Transit Site Plan Review

Subject: **BSO Substation, Pompano Beach, FL, BS #3193**

Broward County Transportation Department, Service and Capital Planning staff has reviewed the **BSO Substation Pompano Beach** Proposed Site Plan Option 5, DD-100, dated 7/9/2020, located at 441 Northwest 27th Ave in the City of Pompano Beach and approves the requested revision as follows:

DD-100

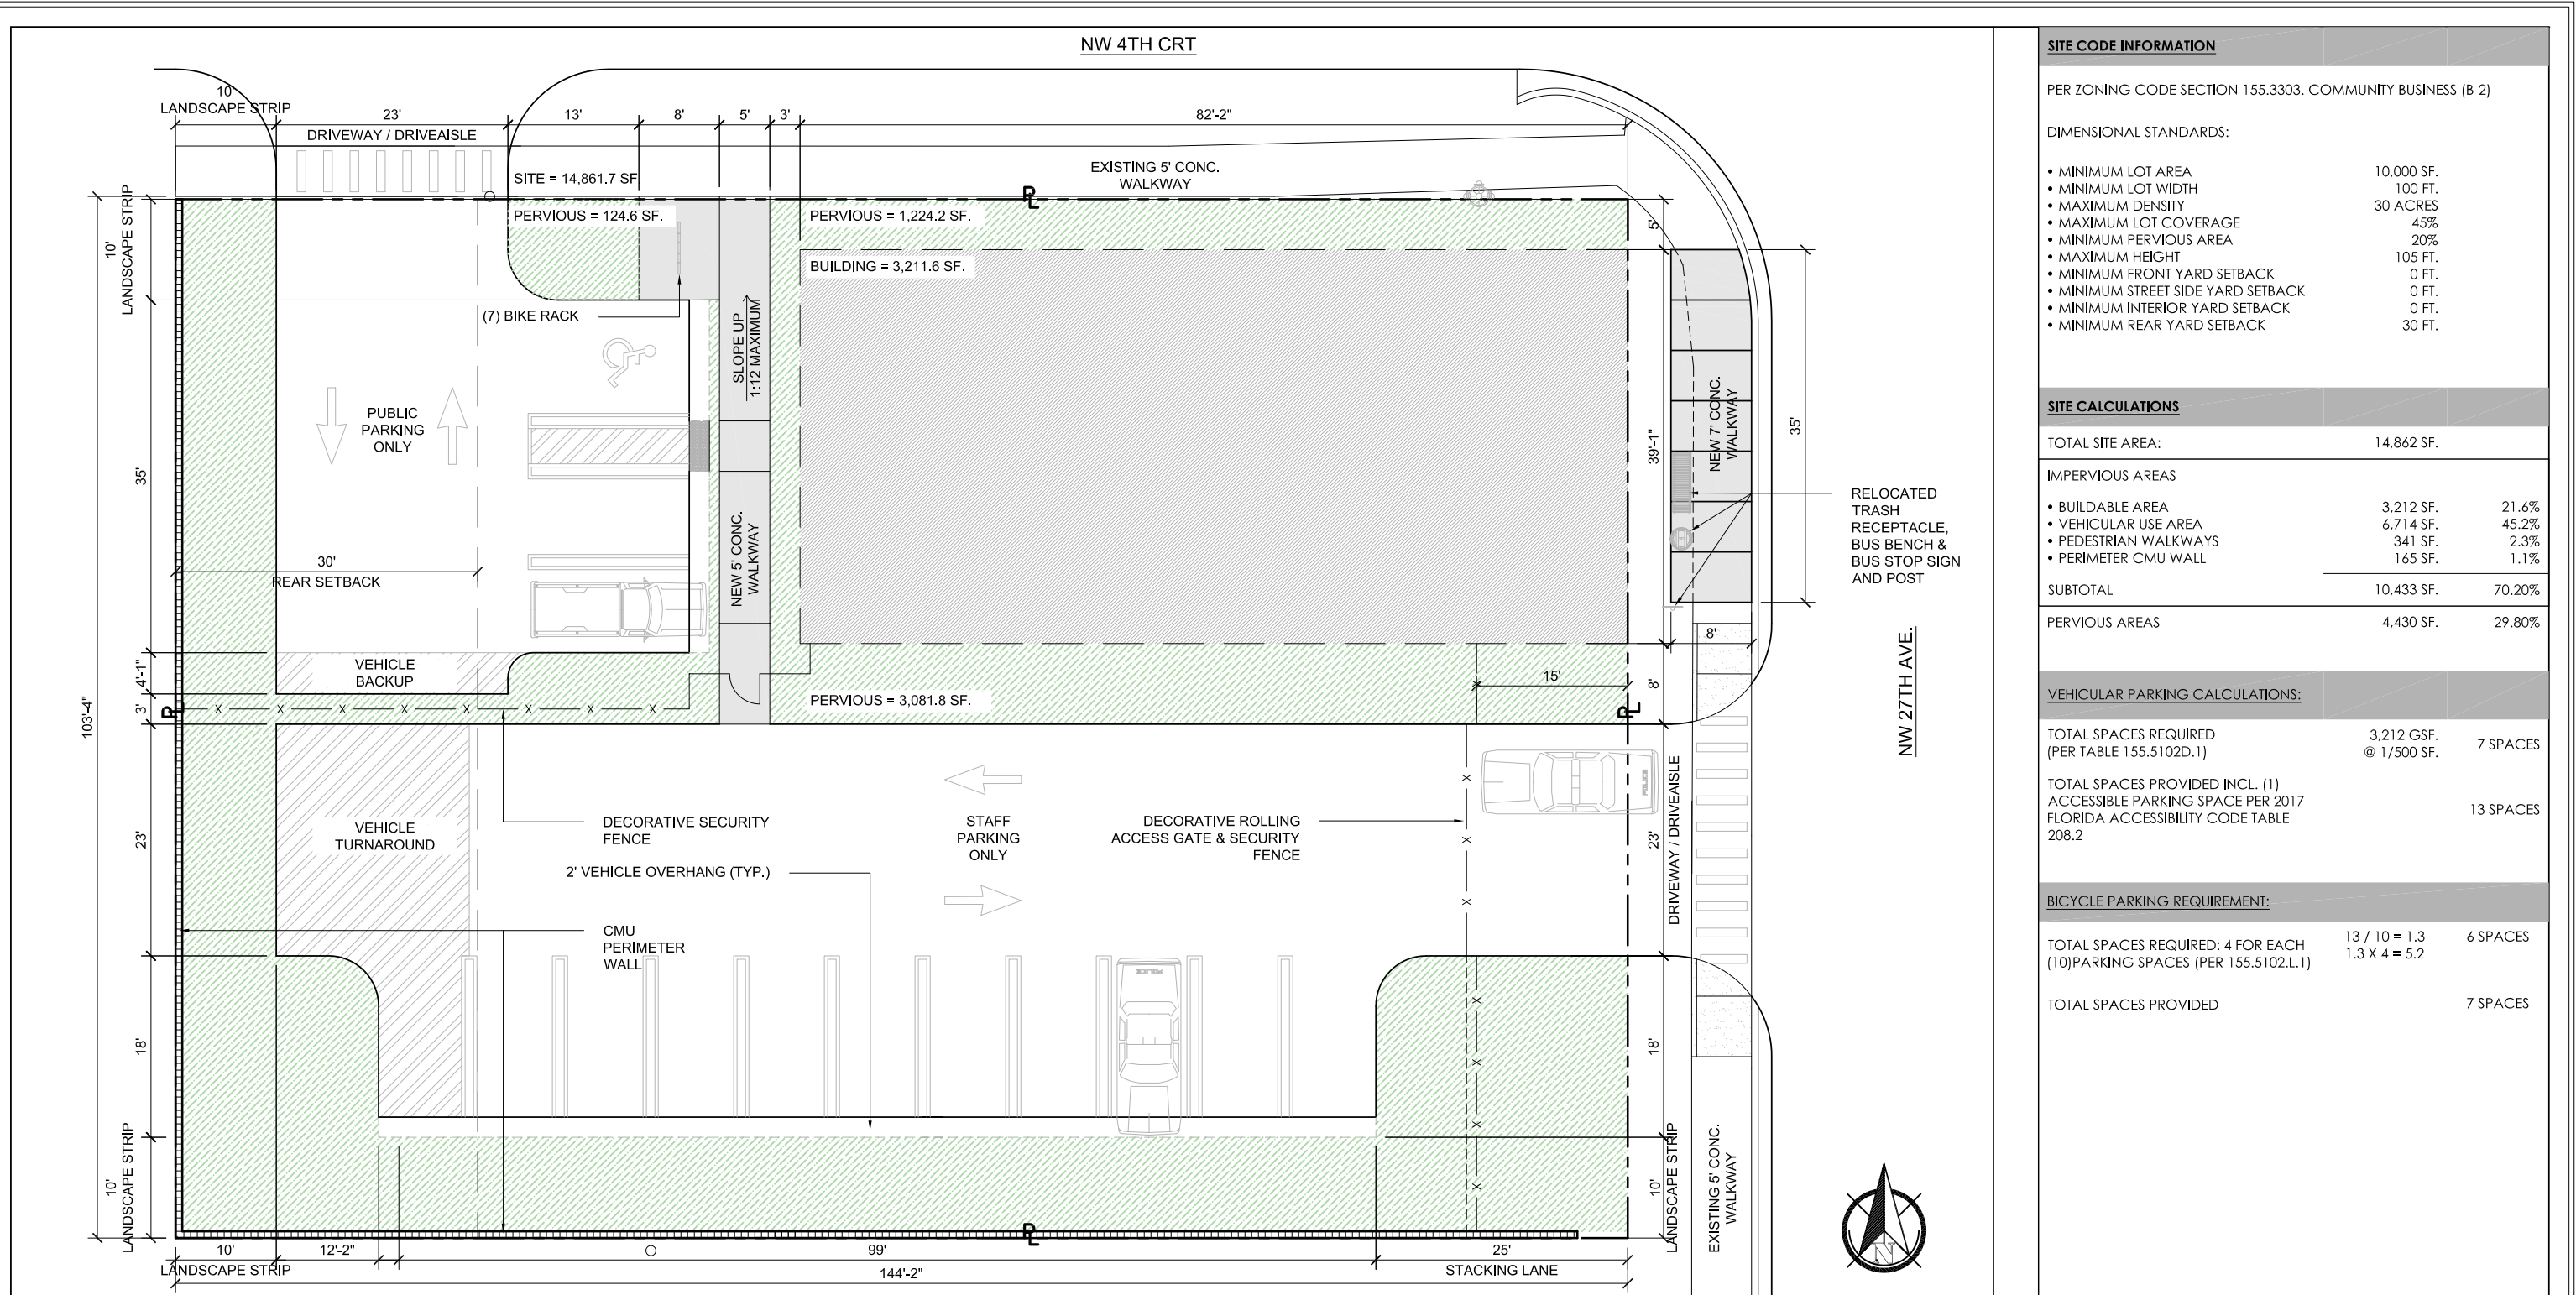
- The project is served by Broward County Transit (BCT) Route 60 on NW 27th Ave with an existing southbound bus stop, **ID# 3193** that will be impacted by the proposed driveway location hence will require the following:
- Construct an 8 foot wide x ~~40-foot~~ **35 feet** long x 6" thick expanded sidewalk for the bus landing pad (design must extend to the face of curb and gutter) on NW 27th Ave commencing 5 feet south of the north property line and continuing south for 40 feet. Design is subject to review by the Service and Capital Planning Section of the Transit Division and the Paving and Drainage Section of the Highway Construction and Engineering Division.
- Refer to revised Site Plan for additional information.
